~~PRELIMINARY~~ DRAINAGE REPORT
FOR
HONOR CHARTER SCHOOL
LOCATED AT
8250 BENT GRASS MEADOWS DRIVE
PEYTON, EL PASO COUNTY, CO 80831

PCD File No. PPR2615

TAIT & Associates, Inc.
320 North Lincoln Ave
Loveland, Colorado 80537
Phone: (970) 613-1447
Fax: (970) 613-1897

April 2026

GRADING PLAN

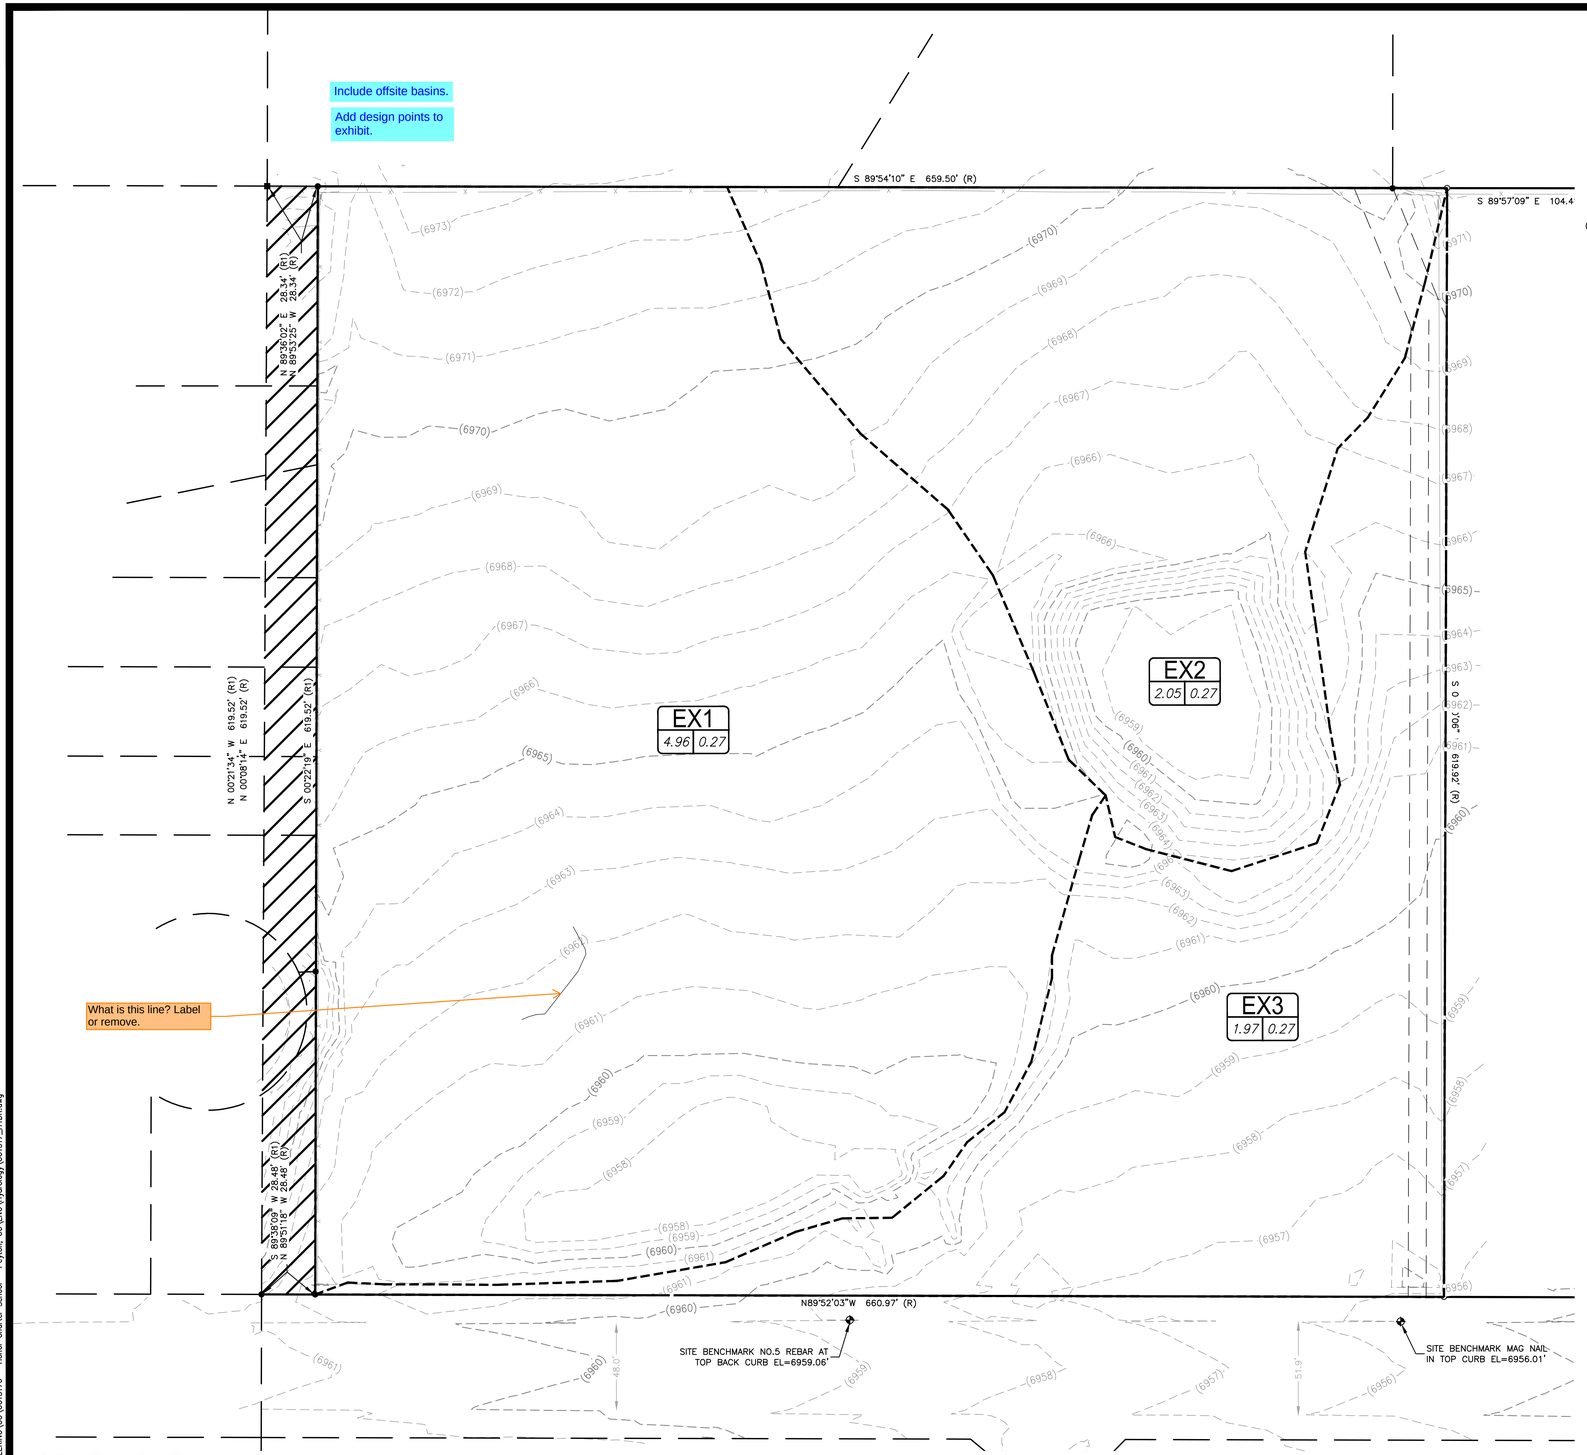
Include offsite basins.

Add design points to exhibit.

What is this line? Label or remove.

GRADING PLAN

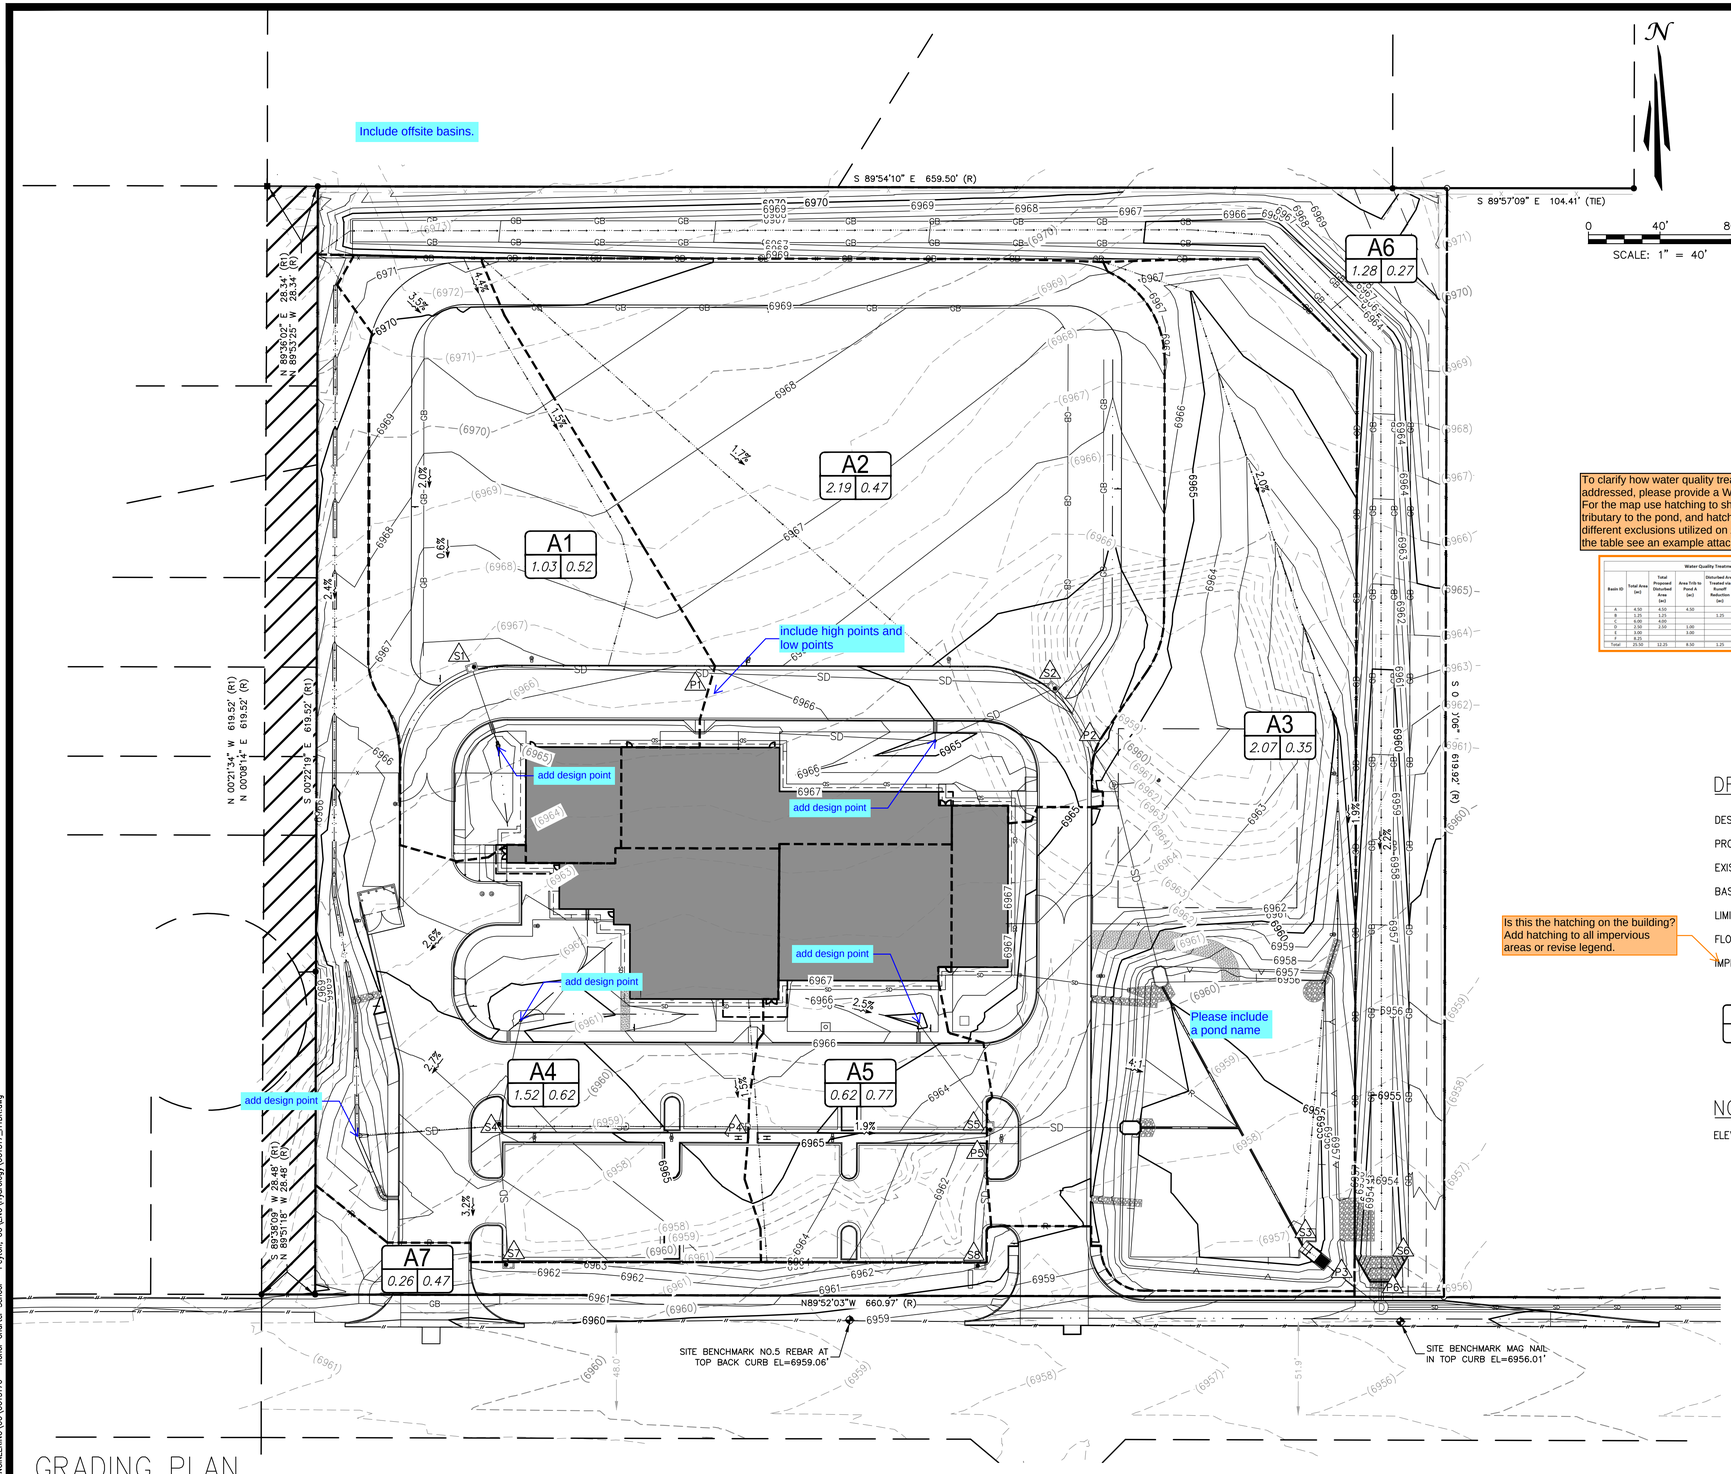
To clarify how water quality treatment is being addressed, please provide a WQ map or table. For the map use hatching to show the area tributary to the pond, and hatching for each different exclusions utilized on AND off-site. For the table see an example attached below.

Is this the hatching on the building? Add hatching to all impervious areas or revise legend.

100-year Emergency Overflow Detention Pond

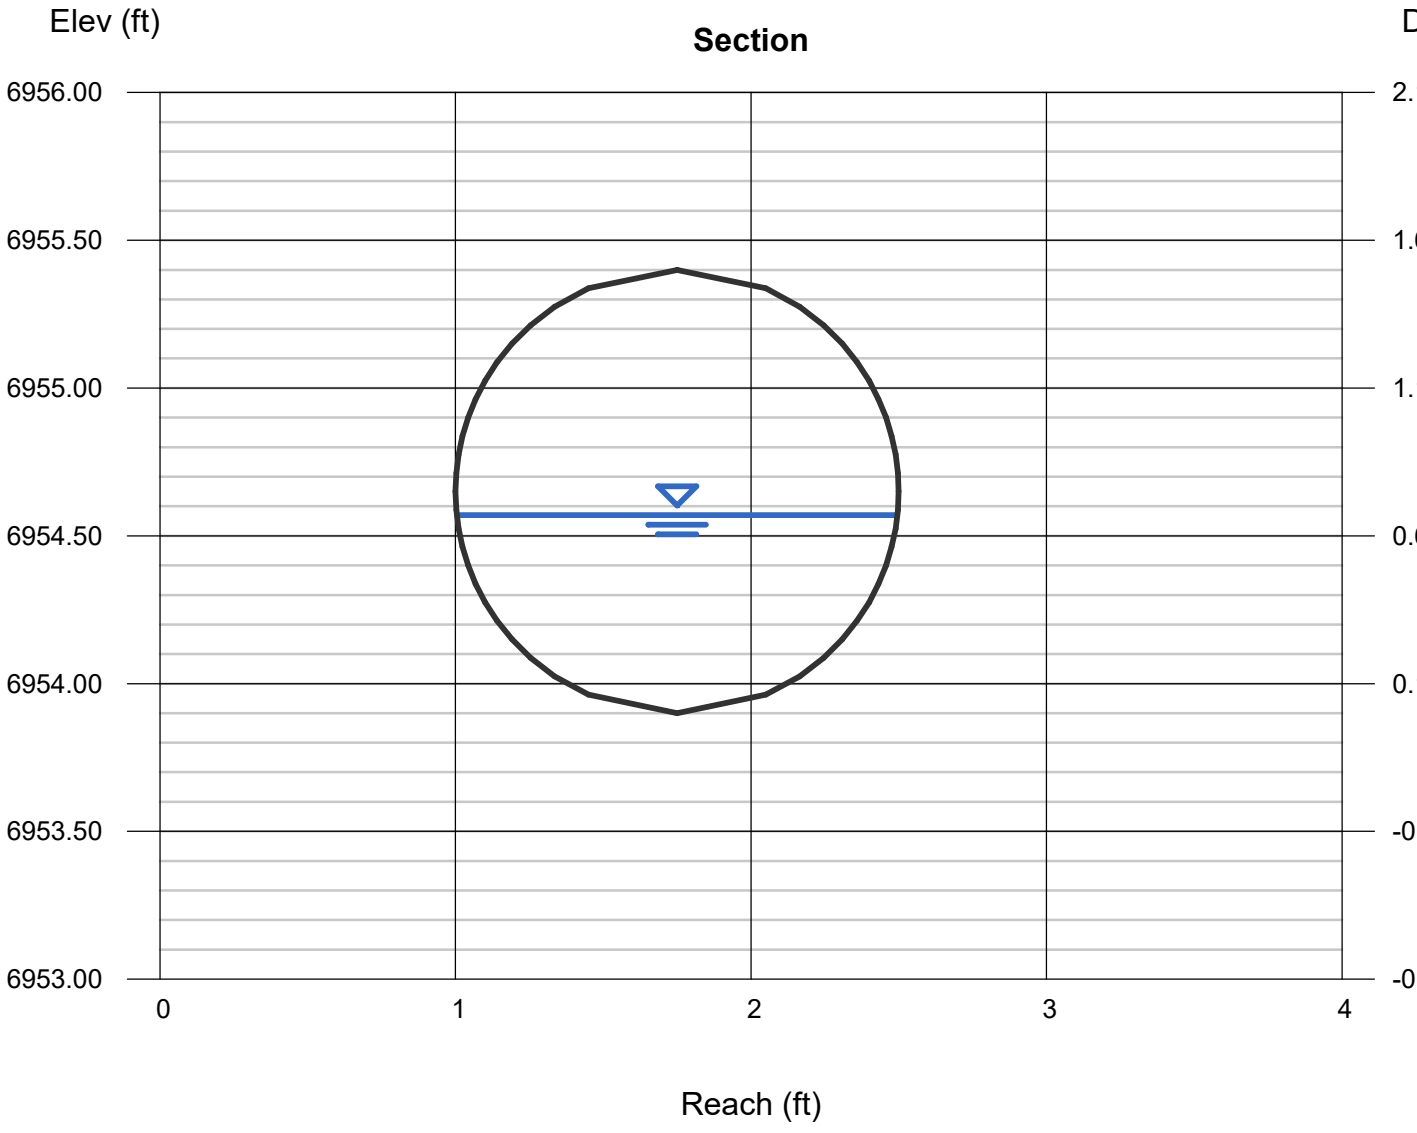
Min freeboard not met
DCM 11.3.2

Channel Report

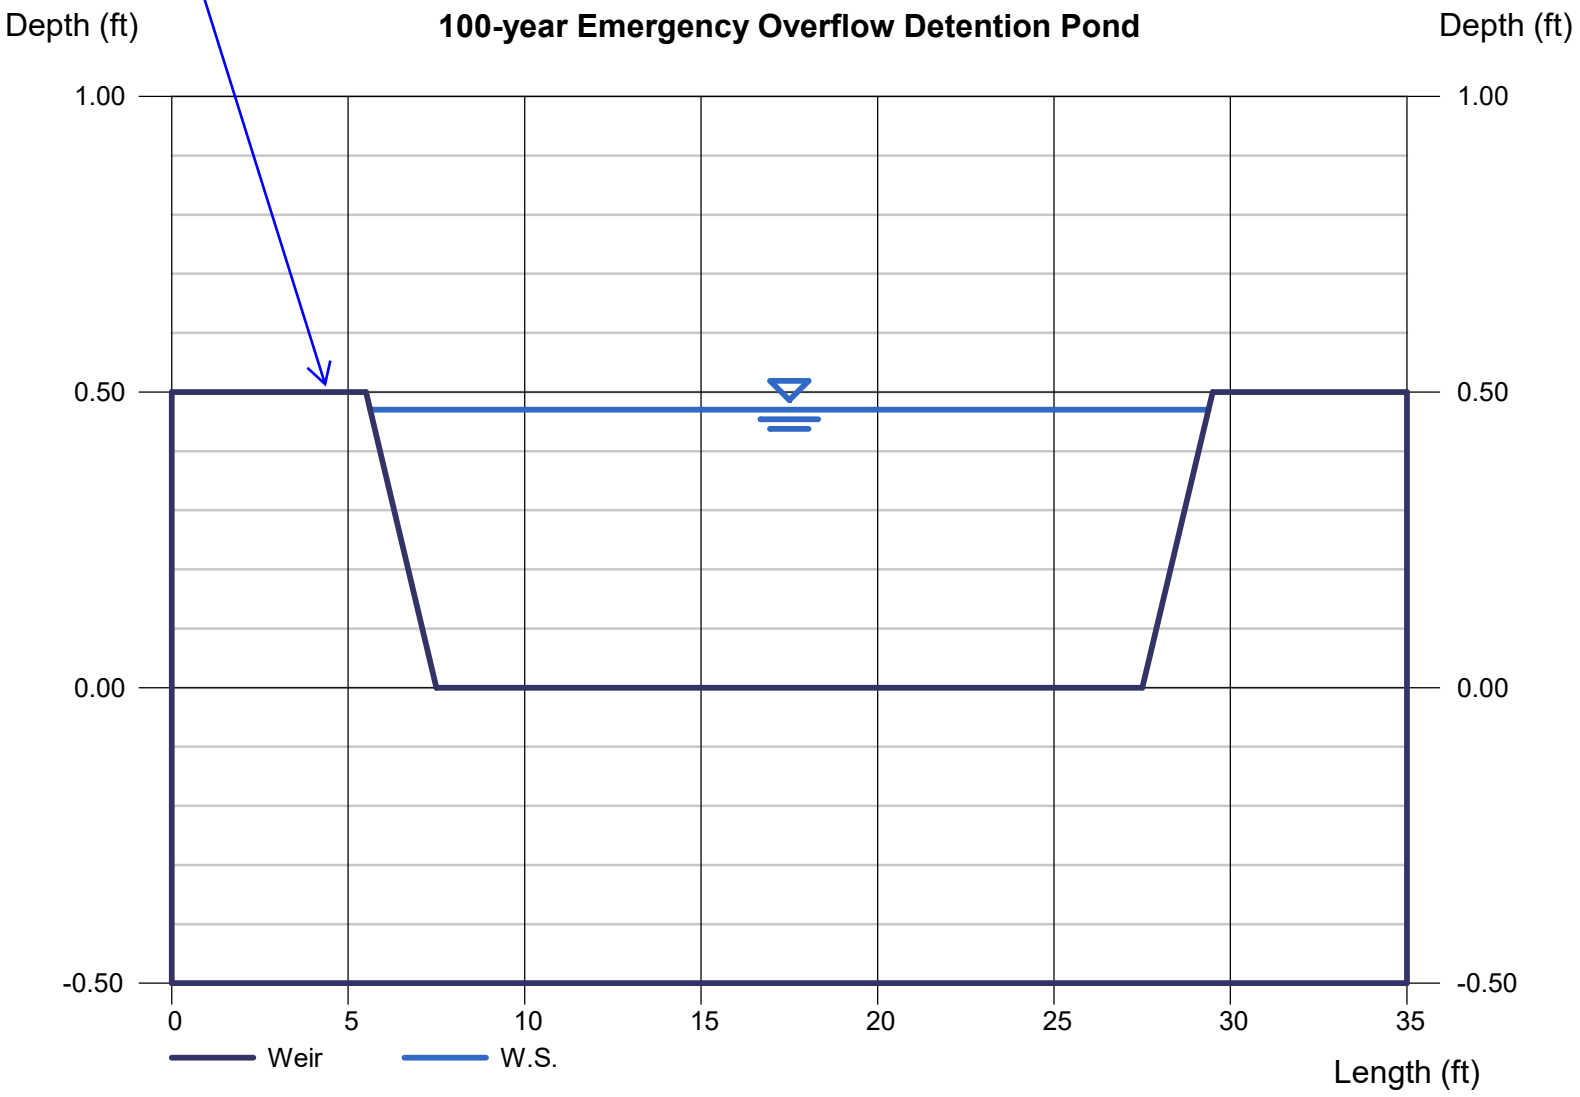
Max side slopes for grass-lined channels is 4:1. Revise design and calculations.

Provide Froude number.

Channel Report

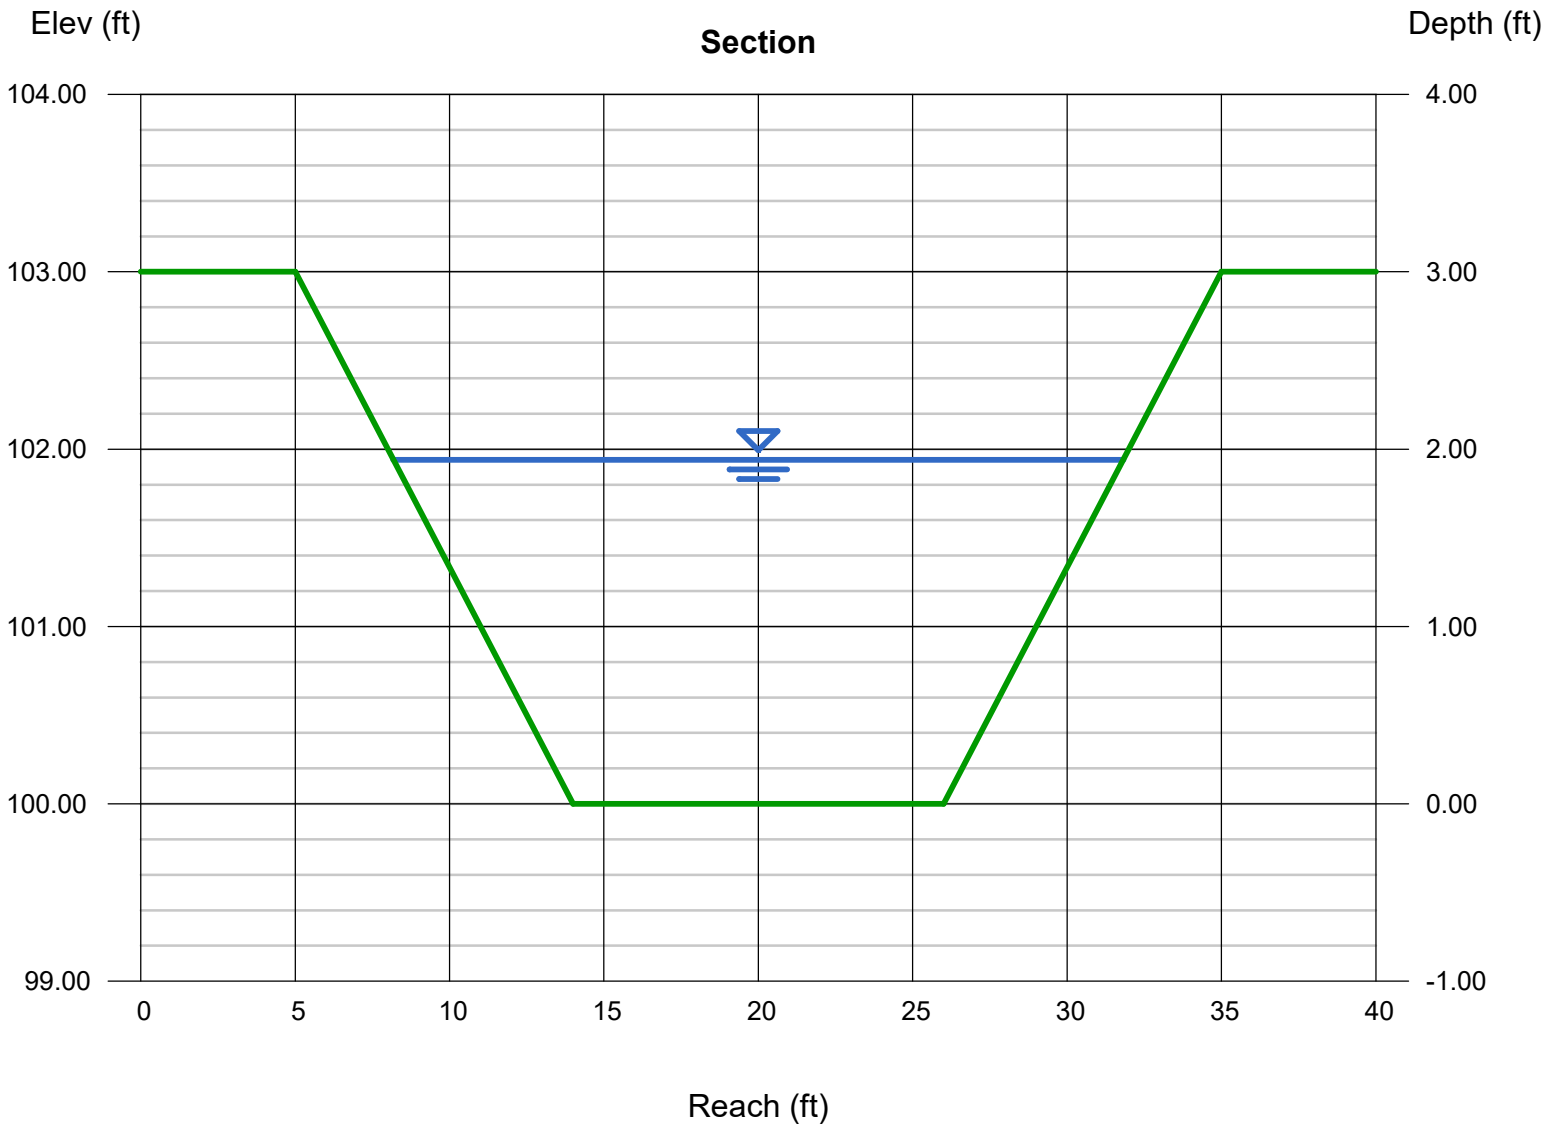
Provide Froude number.
